STONE MILL SUBDIVISION

The purpose of this application is to create a 31-lot subdivision from a metes and bounds parcel.

APPLICATION NUMBER 5 DATE April 19, 2007

DETAIL SITE PLAN

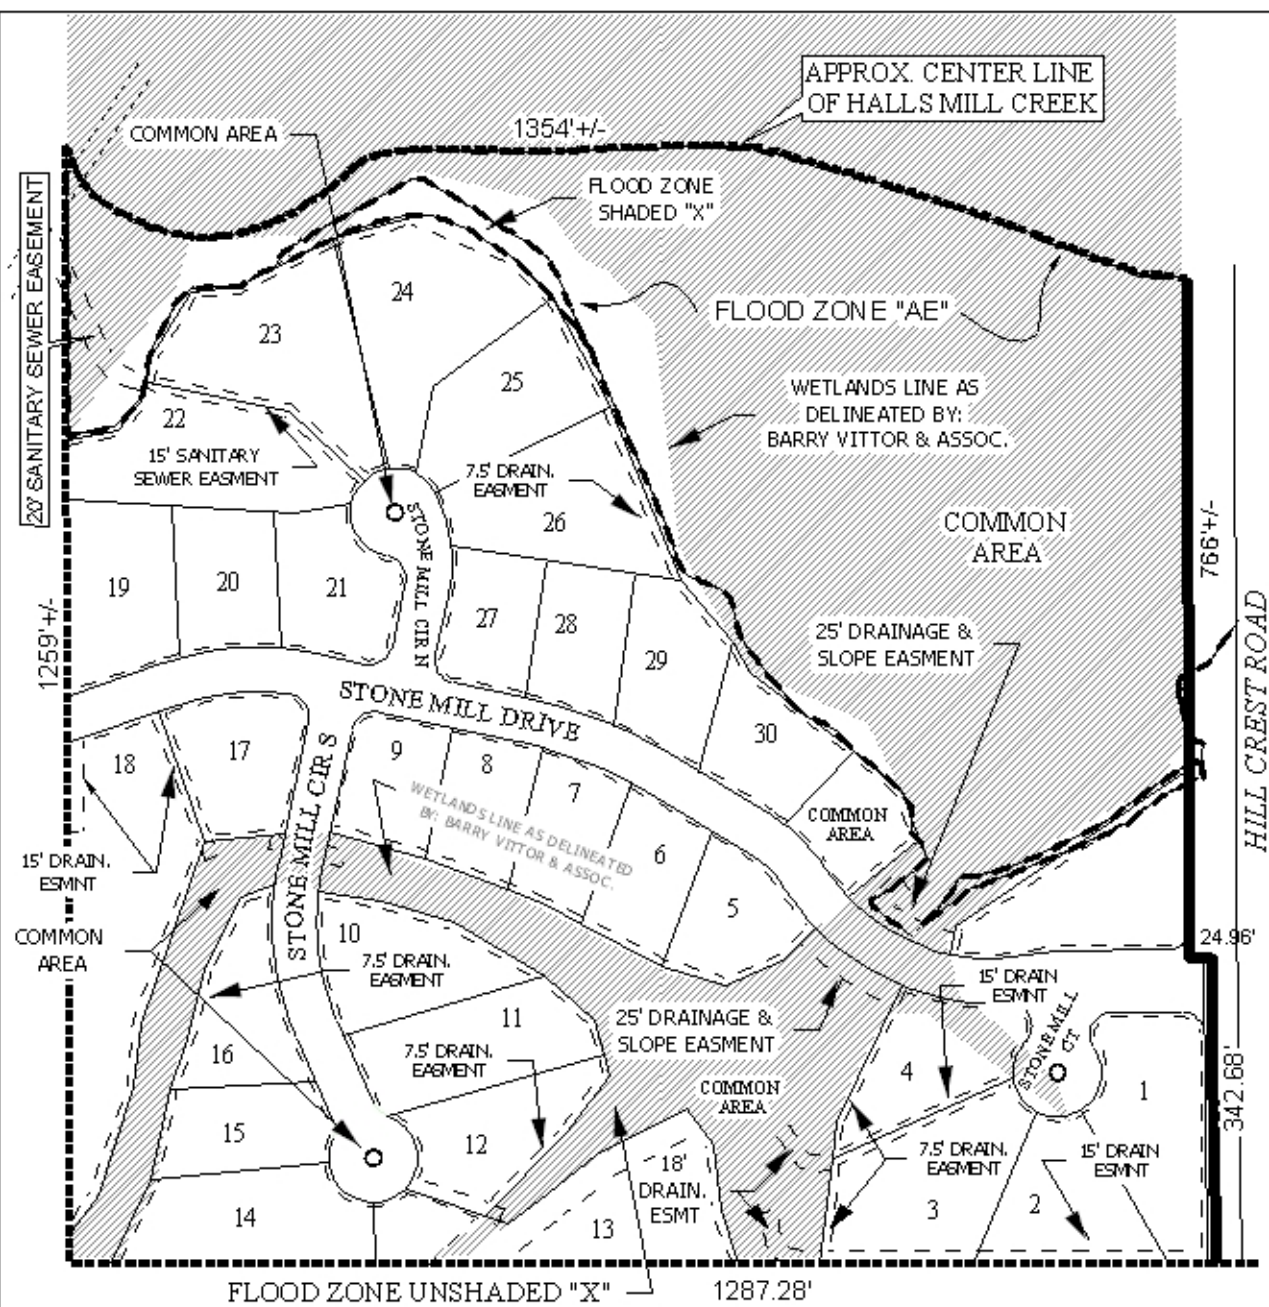
The site fronts Hillcrest Road, which is shown as a major street on the Major Street Plan component of the Comprehensive Plan; and as such, requires a minimum right-of-way of 100-feet. The plat does not indicate the minimum right-of-way width along Hillcrest Road; therefore, the dedication of sufficient right-of-way to provide 50-feet from the centerline of Hillcrest Road would be required. As access to a major street is a concern, Lot 1 and 31 should be denied direct access to Hillcrest Road. Additionally, Lots 1, 4, 9, 17, 21 and 27 are corner lots; therefore, should be allowed only one curb cut with the size, design and location to be approved by County Engineering.

The overall site is bounded by undeveloped parcels to the North, South and West. The development, as currently designed, provides access or a street stub to the parcel to the West (in the area of Lots 18 and 19) not to the North and South as required by the Subdivision Regulations. However, as the parcel to the North would cross a designated wetlands area, Halls Mill Creek, no street stub should be required.

The requirements for street-stubs are based upon Section V.B.1. of the Subdivision Regulations, which states: "The street layout shall also provide for the future projection into unsubdivided lands adjoining of a sufficient number of streets to provide convenient circulation." The parcel West of the site is approximately 42± acres, while the parcel South of the site is approximately 20± acres. All adjacent parcels are currently undeveloped; however, the trend of this area is towards new residential subdivisions. The size of the parcels to the West and South of the site are such as to likely be the subject of future subdivision applications, hence the provision of a street-stub to the South in the vicinity of Lots 13 and 14 should be required.

The site illustrates wetlands on a portion of the site and since the presence of wetlands are indicated on the preliminary plat the area may be environmentally sensitive; therefore, the approval of all applicable federal, state and local agencies would be required prior to the signing of the Final Plat.

An area is shown on the preliminary plat along the western boundary with a 20-foot access from the new street and a 30-foot access between Lots 9 and 10, thus a note should be placed on the Final Plat stating that maintenance of the common area will be the responsibility of the property owners.

The 25-foot minimum building setback lines, required in Section V.D.9., are not shown, but would be required on the final plat.

The plat meets the minimum requirements of the Subdivision Regulations and is recommended for Tentative Approval subject to the following conditions: 1) dedication of sufficient right-of-way to provide a minimum of 50-feet from centerline of Hillcrest Road; 2) the placement of a note on the Final Plat denying Lots 1 and 31 direct access to Hillcrest Road; 3) the placement of a note on the Final Plat stating that Lots 1, 4, 9, 17, 21 and 27 are corner lots; be limited to one curb cut with the size, design and location to be approved by County Engineering; 4) the dedication of appropriate radii at the intersection of Hillcrest Road and the new street as determined by County Engineering; 5) labeling of each lot with its size in square feet, or provision of a table on the plat with the same information; 6) placement of a note on the plat stating that approval of all applicable federal, state and local agencies is required prior to the signing of the Final Plat; 7) the provision of a street-stub to the South in the vicinity of Lots 13 and 14; 8) provision of a certification letter from a licensed engineer to the Planning Section of Urban Development and the Mobile County Engineering Department, certifying that the stormwater detention and drainage facilities comply with the City of Mobile stormwater and flood control ordinances prior to the signing and recording of the final plat; 9) placement of a note on the Final Plat stating that any lots which are developed commercially and adjoin residentially developed property must provide a buffer, in compliance with Section V.A.7. of the Subdivision Regulations; and 10) the depiction of the 25-foot minimum building setback lines along Hillcrest Road and the new streets.
